PROPOSAL:
PROPOSAL: PROPOSED LOFT CONVERSION WITH GABLE / REAR FLAT ROOF DORMER; FORMING BEDROOM.

DRAWING TITLE:
PROPOSED SECOND FLOOR PLAN.

PAPER	SCALE	DATE	DRAWING No	REV
A3	1:50	10/25	M4632/04/104	A

PROPOSED SECOND FLOOR PLAN

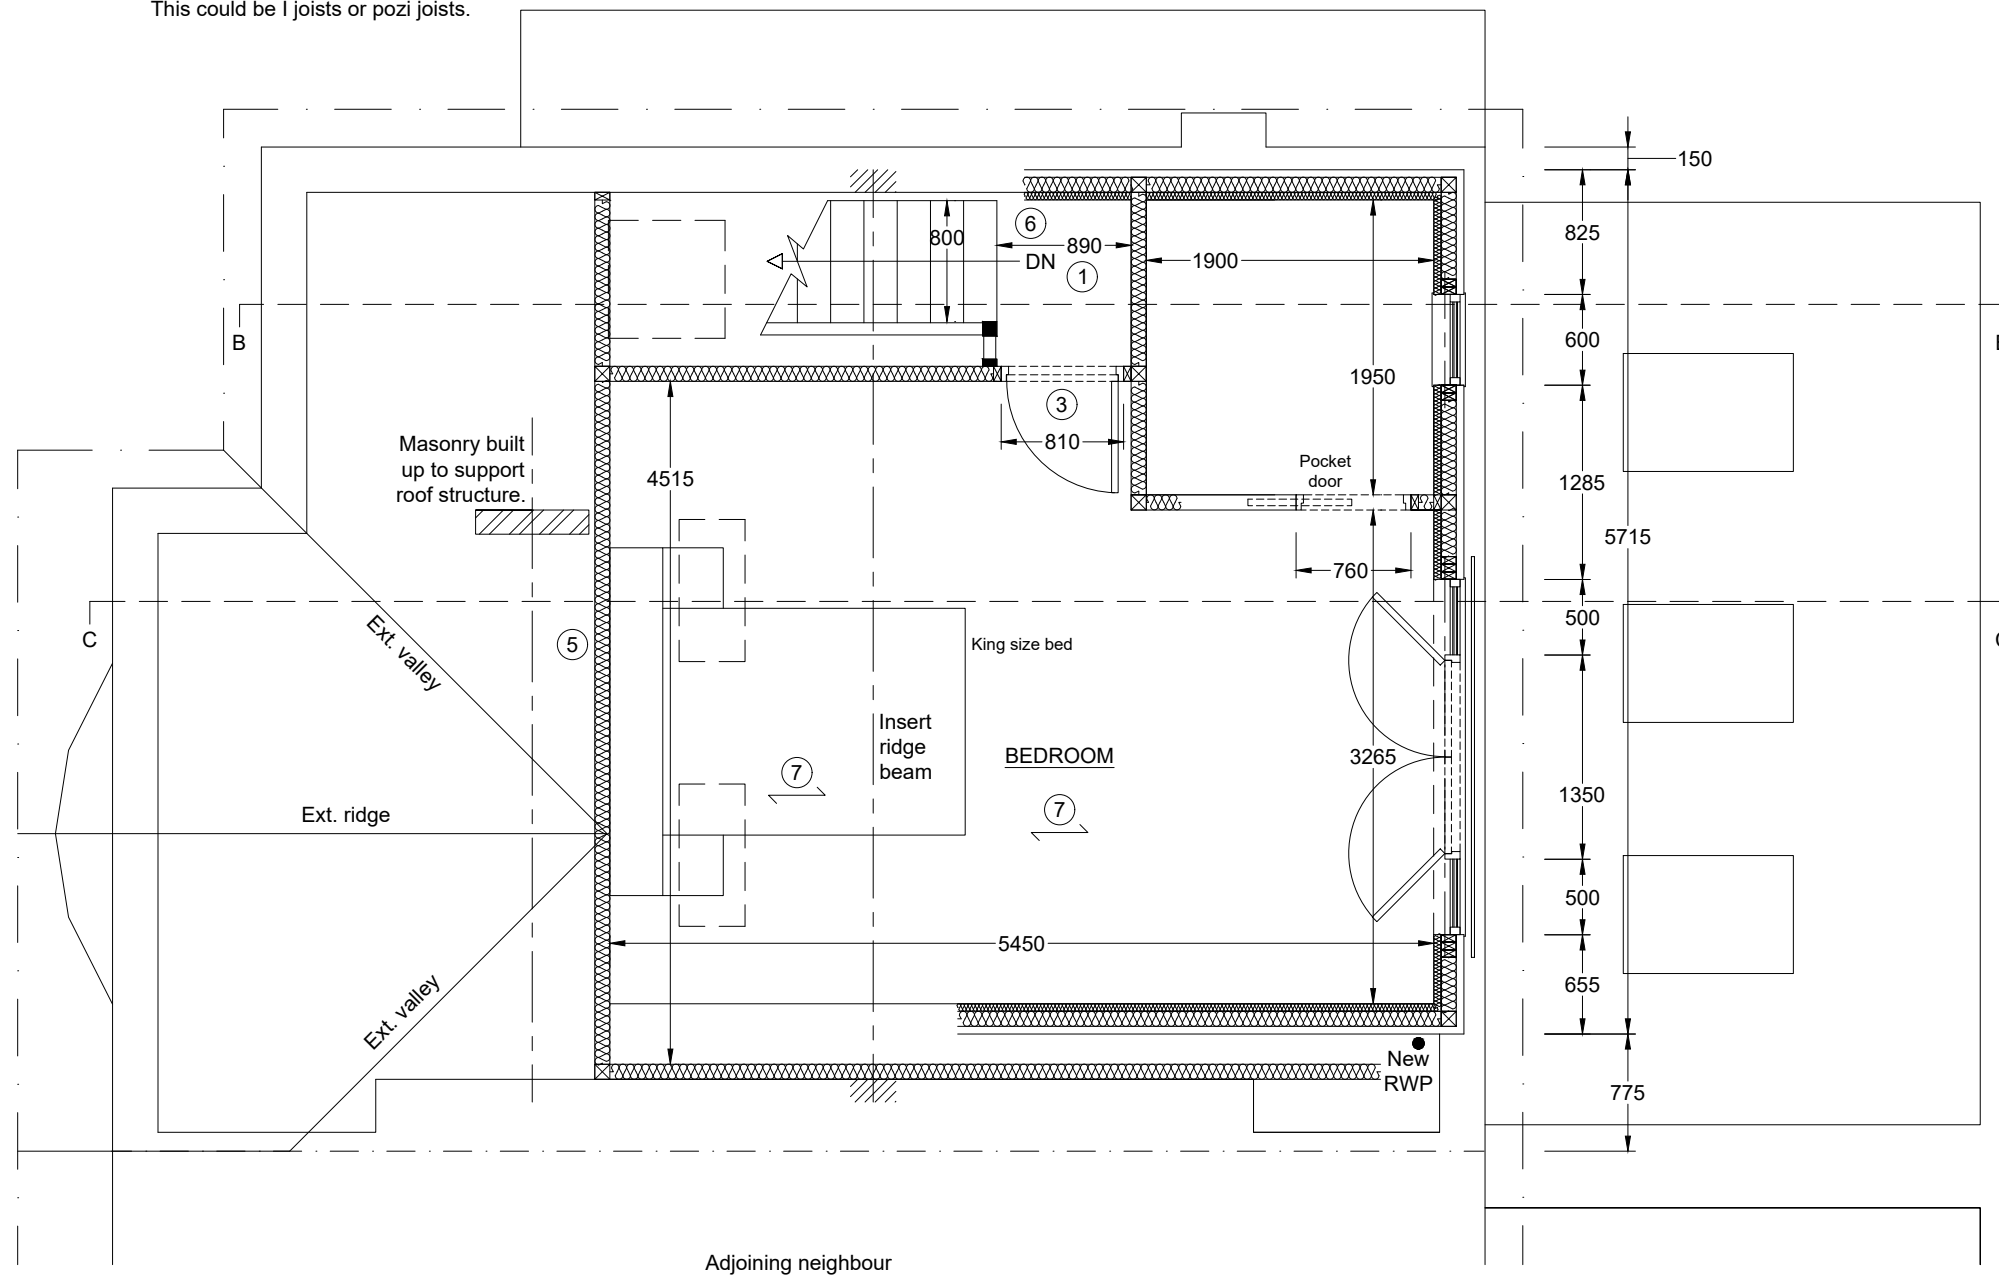
Rev.A Reverted new S&VP to ext. S&VP to suit Planning Officers comments. 23.03.26
